ZONING CHANGE REVIEW SHEET

CASE: C814-2014-0120 – Austin Oaks Planned Unit Development

OWNER/APPLICANT: Twelve Lakes, LLC (Jon Ruff)

EXHIBIT G

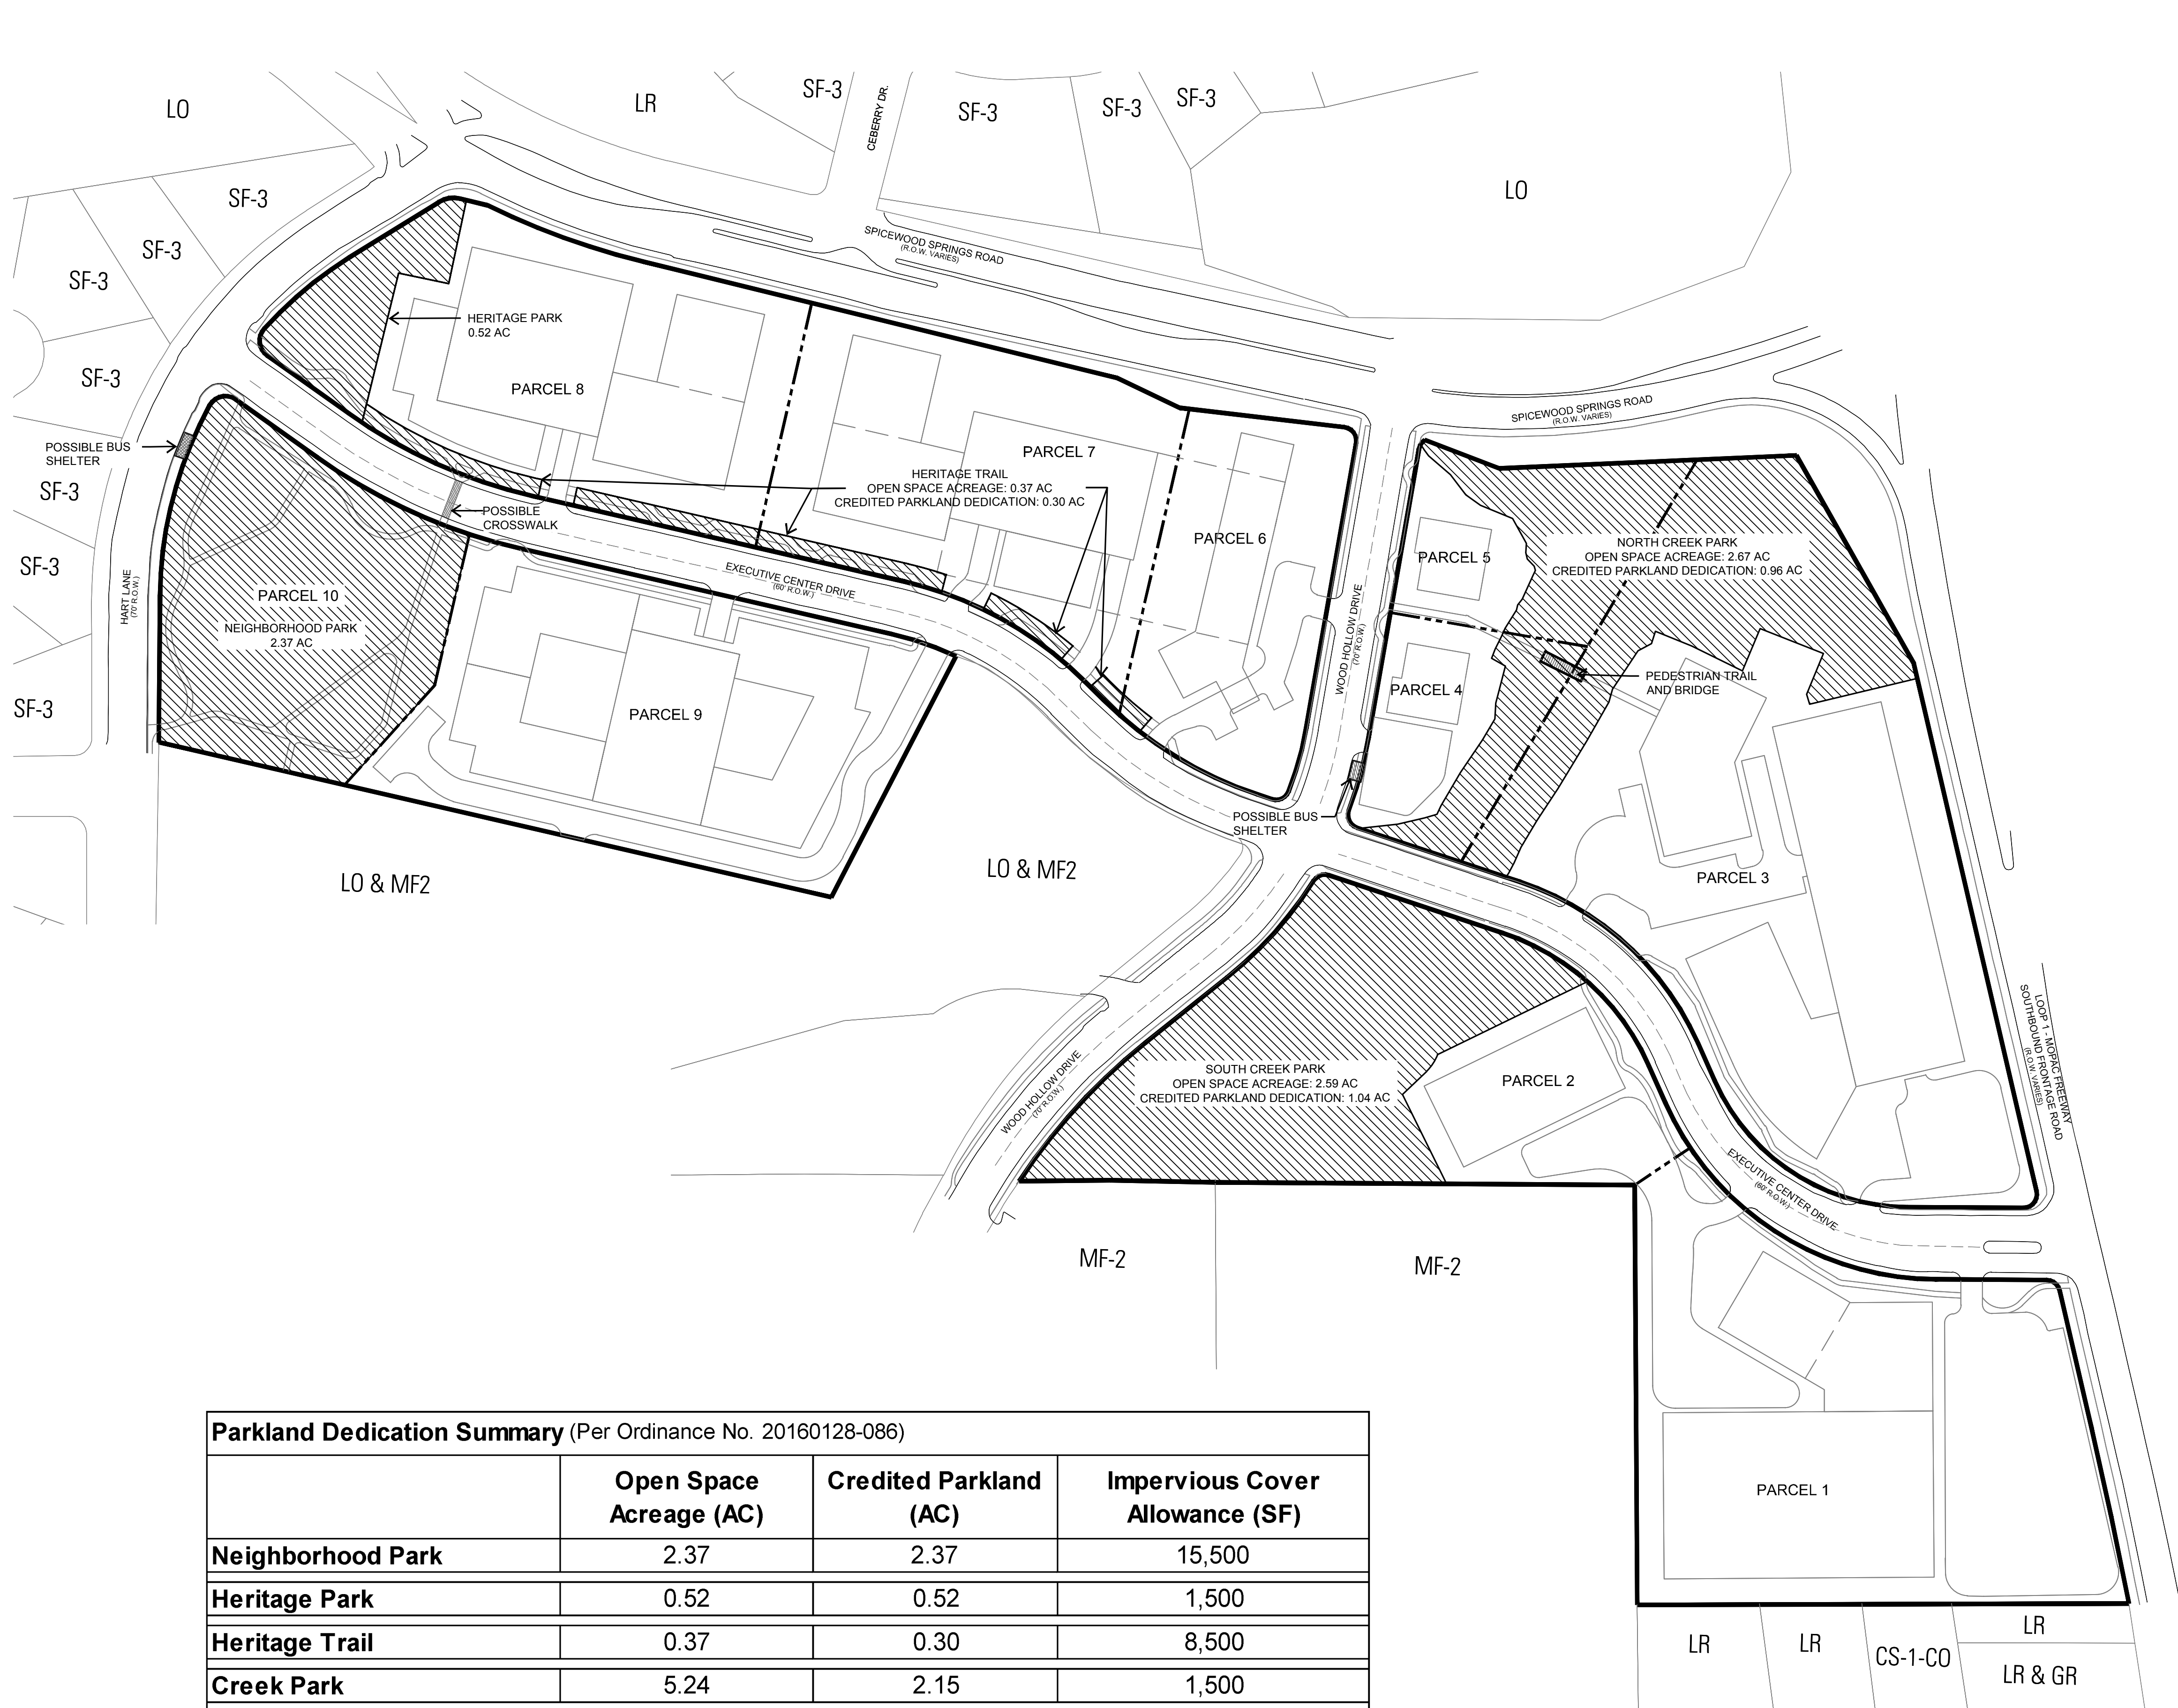
EO 34. The Parkland Dedication Summary table allocates 14,000 square feet of impervious cover for the Creek Park. Is this number intended to include the trail? If the trail is public it will not count towards the impervious cover limit; however, the square footage of noncompliant development does need to be calculated and incorporated into the PUD. Please clarify whether the 14,000 square feet includes the trail and if so, provide the estimated size of the trail. Any requested park development that would not comply with CWQZ or CEF buffer requirements should be subtracted from the proposed restoration area. See comment EO 7.

EXHIBIT I

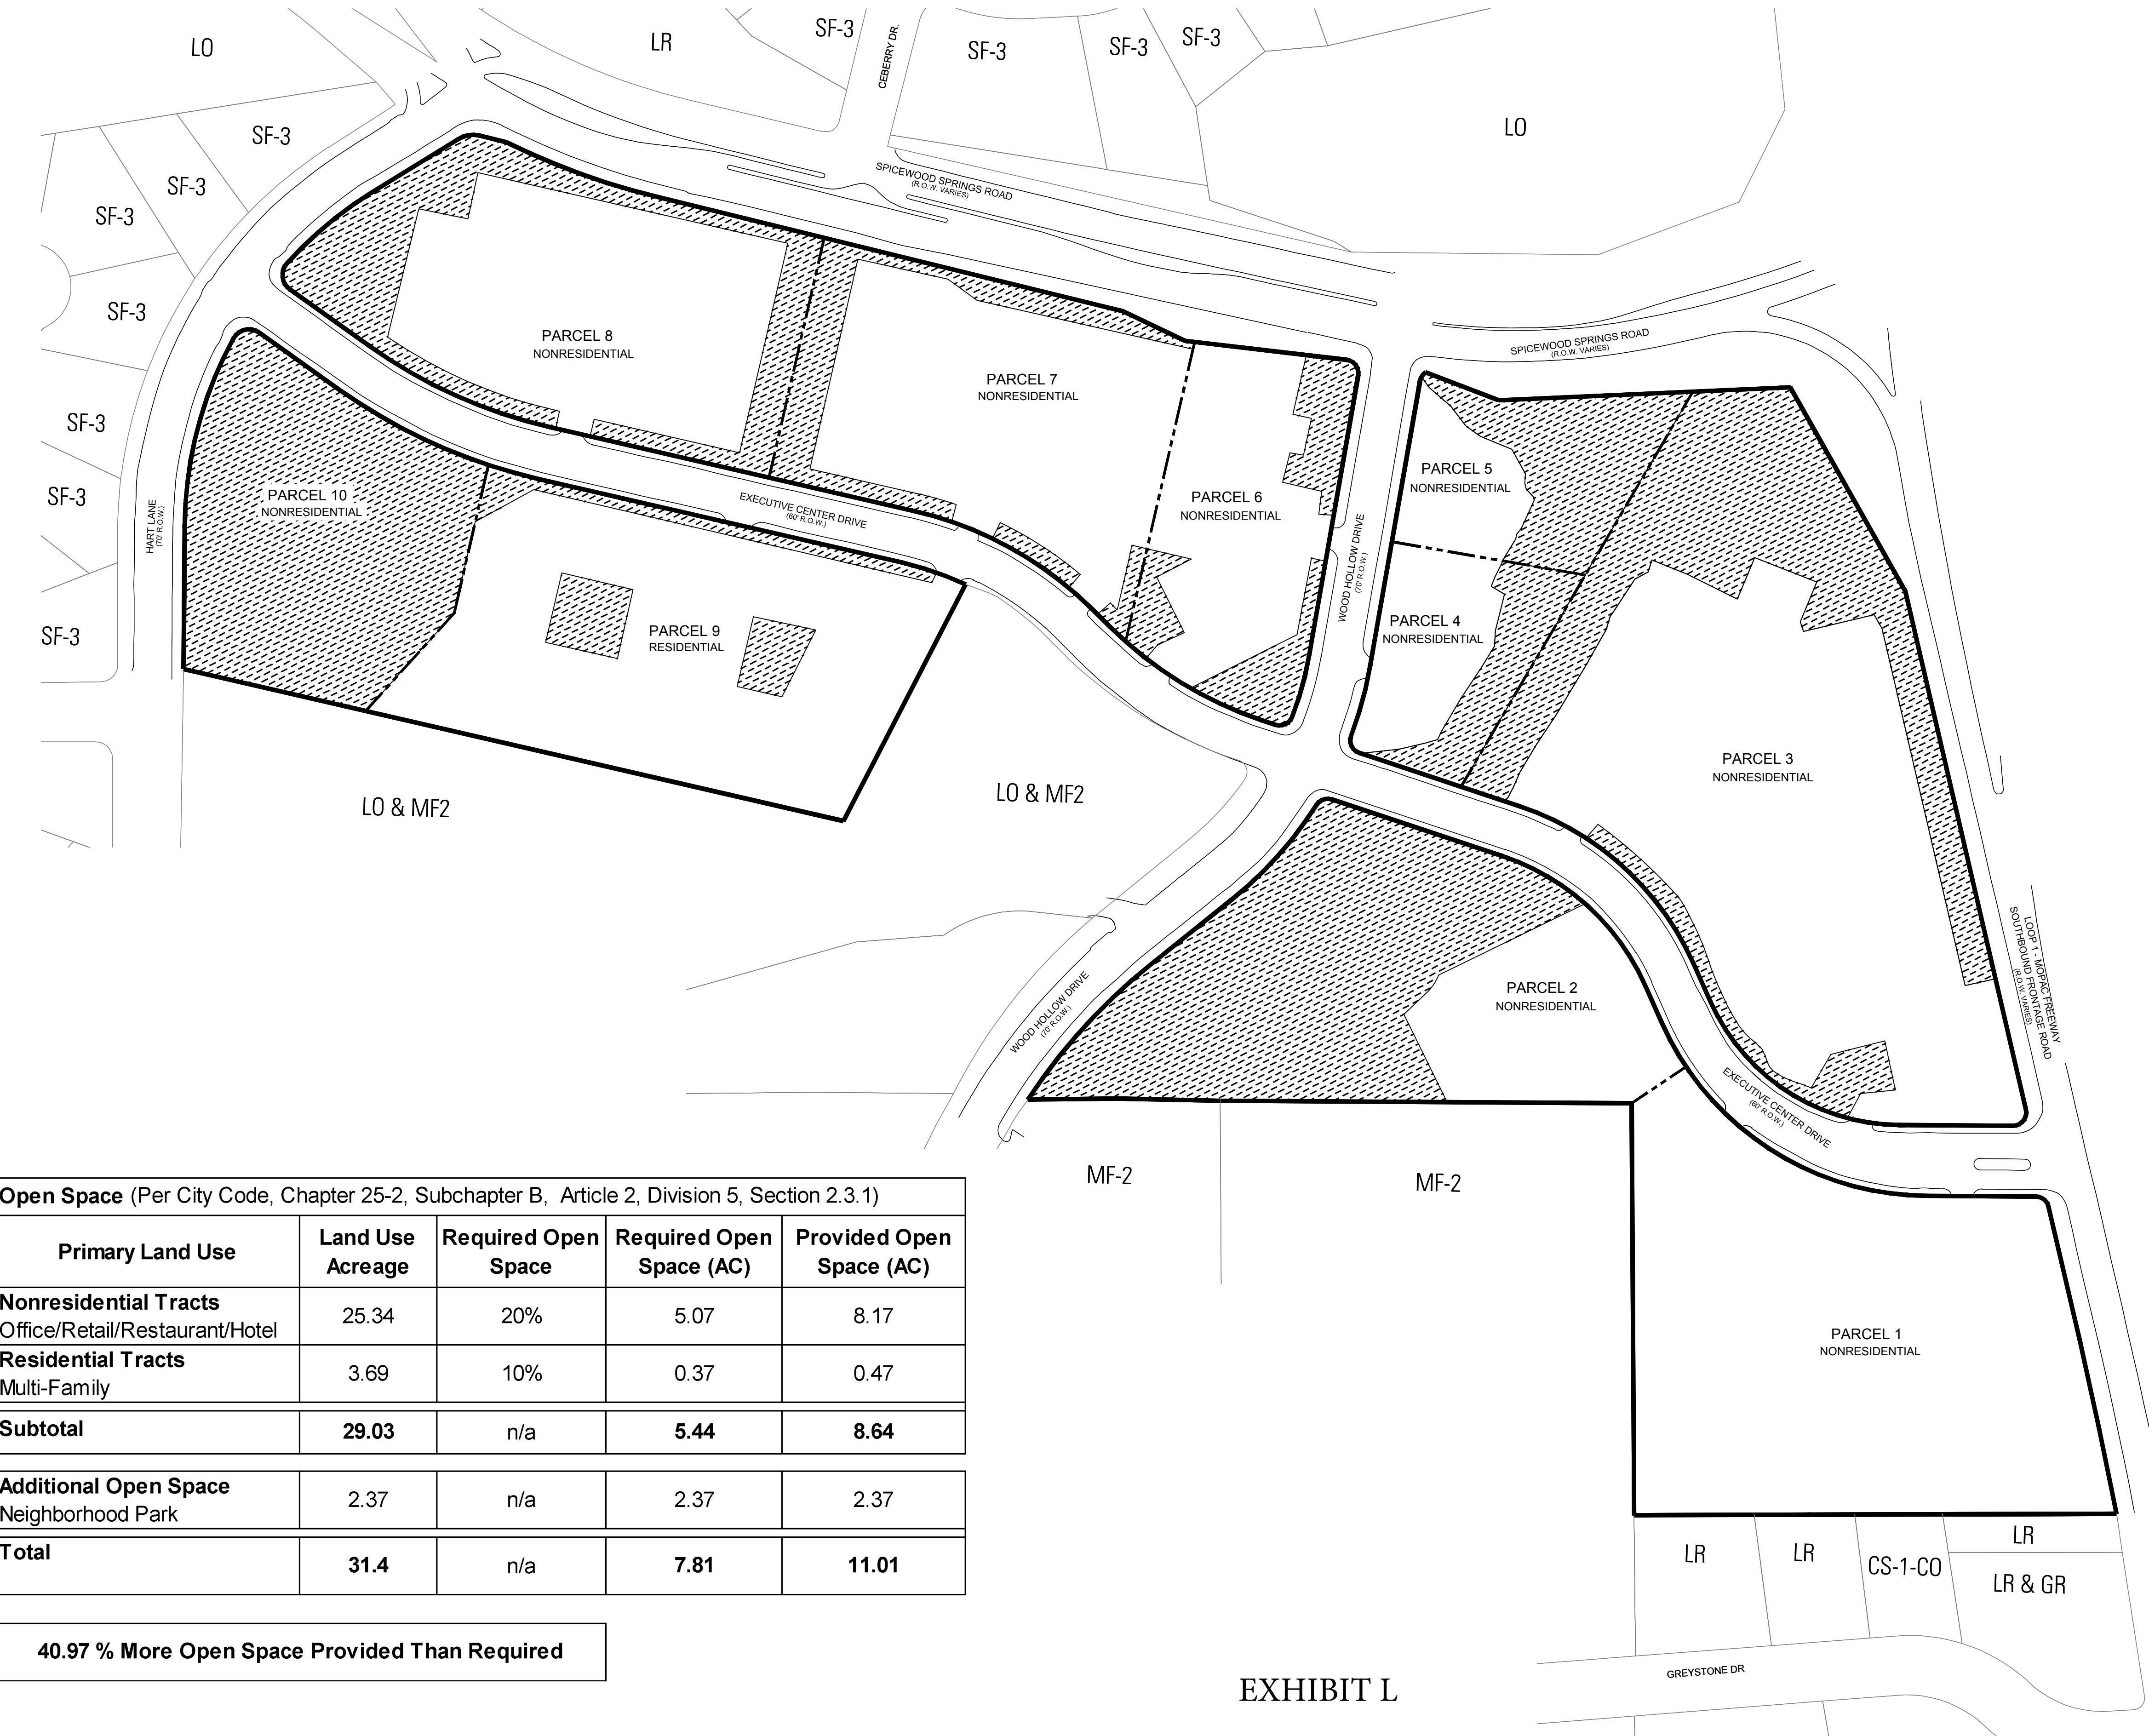
EO 17. As noted in EO [15], the boundaries on this exhibit are difficult to read. Please revise the symbology to better illustrate the environmental features and restoration areas, and remove any information that is not necessary for PUD review (e.g., EHZ, drainage easements, etc.).

Update 4: There are several places where the 100-year fully developed floodplain extends beyond the identified CWQZ. Please correct the CWQZ boundaries to follow the 100-year fully developed floodplain in areas where the floodplain width is between 50' and 400' from the creek centerline. (Maintain a minimum CWQZ width of 50' where the floodplain is narrower than 50' from centerline.)
